Licence Number	L4247/1991/13
Licence Holder	Talison Lithium Australia Pty Ltd
ACN	139 401 308
Registered business address	Level 4 37 St Georges Terrace PERTH WA 6000
Date of amendment	5 May 2017
Prescribed Premises	Category 5: Processing of Metallic and Non-Metallic Ore
Premises	Talison Lithium Mine Mining Tenements M01/3, M01/6, M01/7, M01/16, G01/1 and G01/02 GREENBUSHES WA 6254

Amendment

Amendment Notice

Figure 1: Management actions proposed by the Licensee for IR5

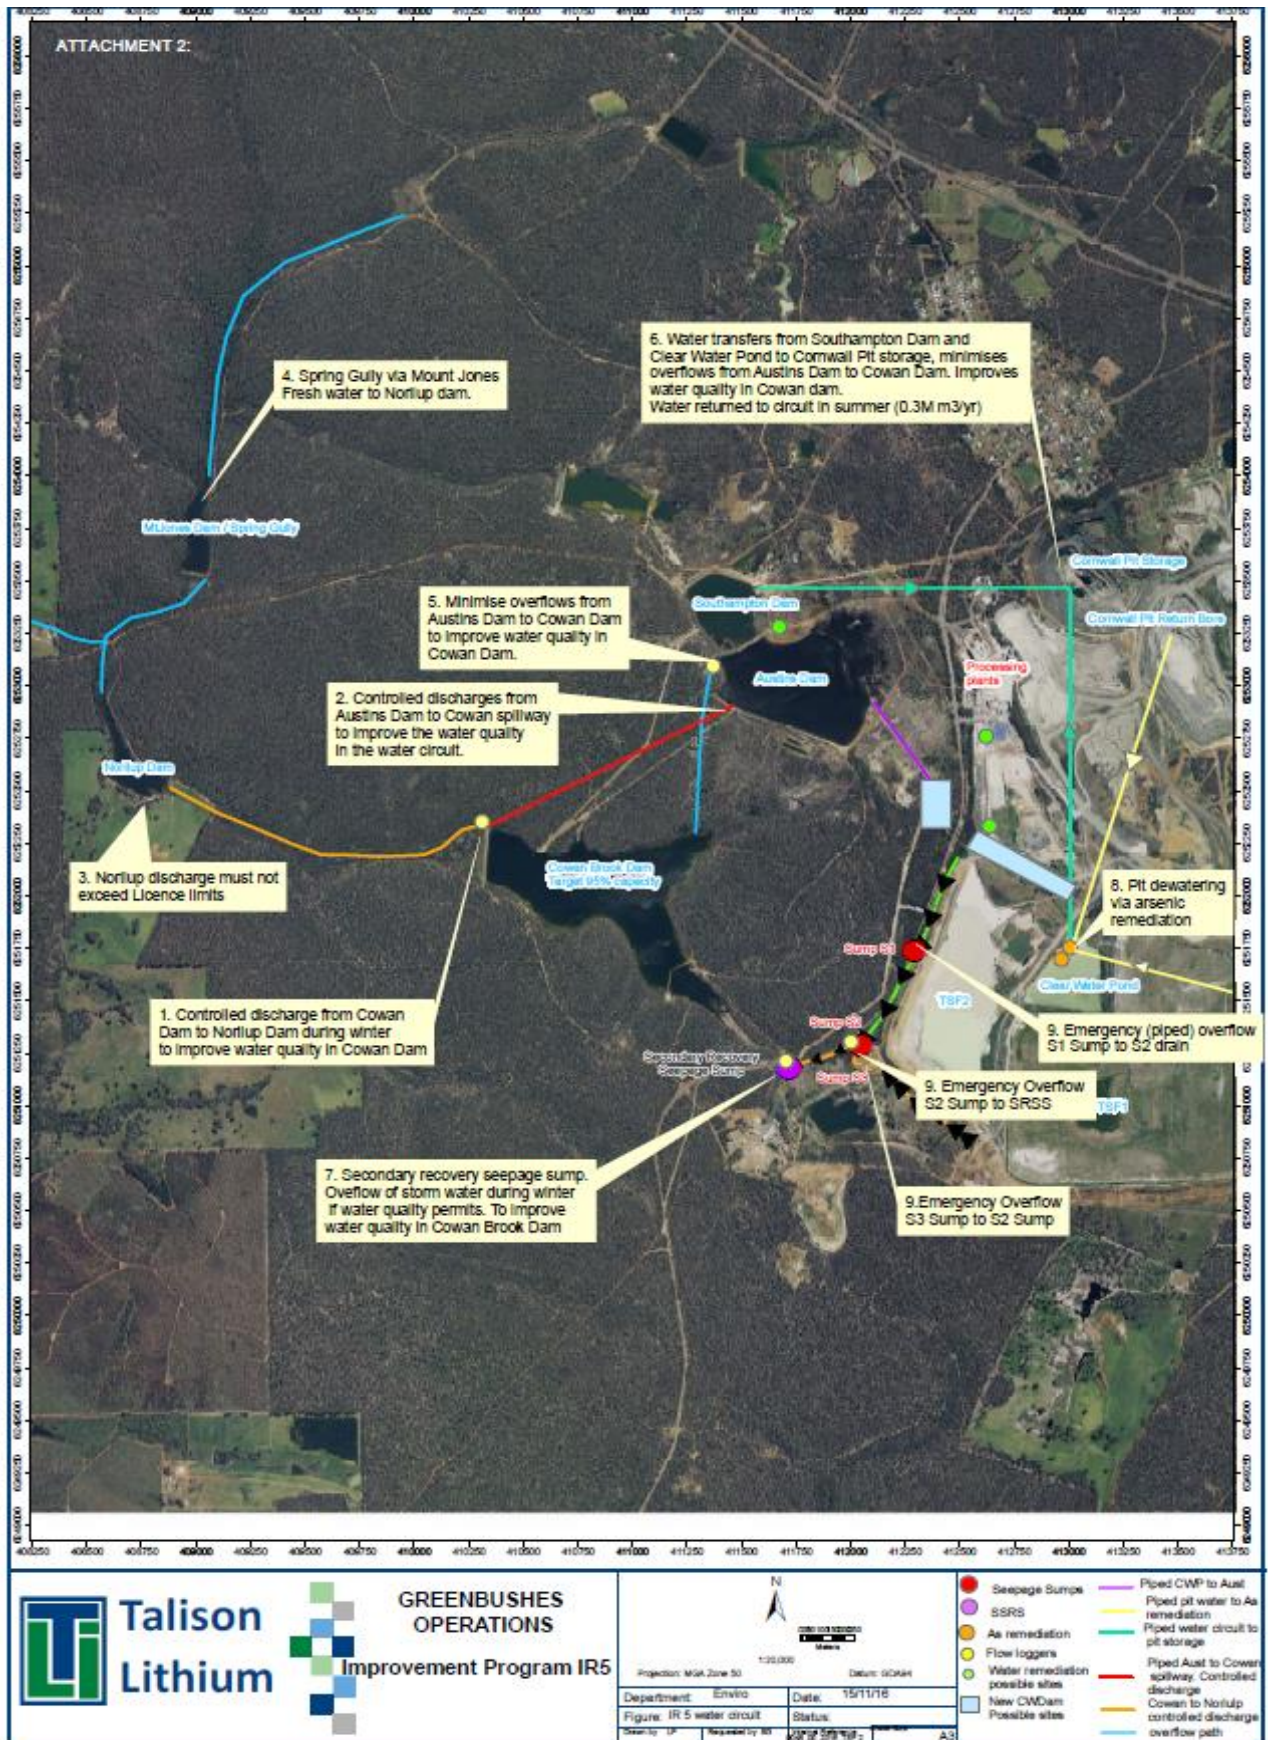
The Licensee's proposed improvement program includes a provision for managed discharges from Cowan Brook Dam to Norilup Dam during winter, with the discharge (as shown by point 1 and discharge route in orange in Figure 1 following) diluted by flows from the upstream Spring Gully to Norilup Dam (shown in blue as point 4) to reduce contaminant concentrations in Norilup Dam (point 3).

The regulatory controls arising from IR5 are not considered further here and will be addressed as part of DER's forthcoming assessment of the Licensee's application for a further Licence amendment to increase the production capacity of the Chemical Plant.
